# Access Compliance Report

## Public Rights-of-Way

Intersection ID: 13151	Main Street: MERRIMAN_AV	Cross Street: SPRUCE_ST	Location: SW
ADA ID: 296DFB01277F	Ramp Type: ParaDiag	Initial Pass/Fail: Fail	Overall Compliance: No
Codes/Mitigation Info/Possible Solution		Field Measurements/Component Compliance	
Severity Score: 12.5

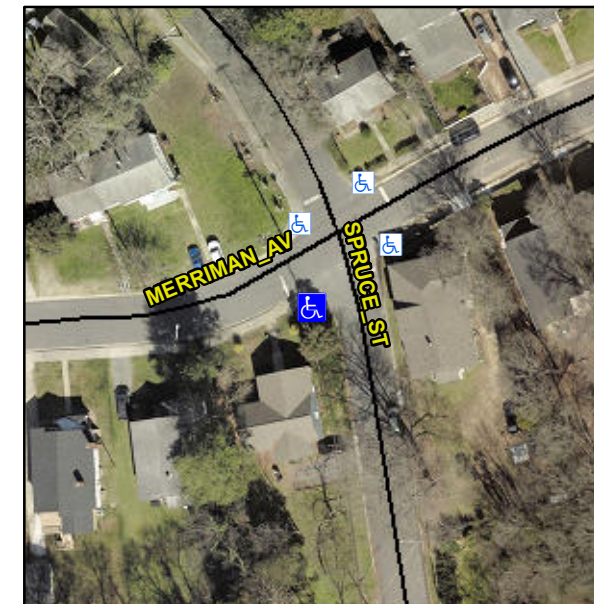
**RT RP < 5%**

**R304.3.2**

**Remove & Replace Curb Ramp With Two New Directional Ramps or Equivalent.**
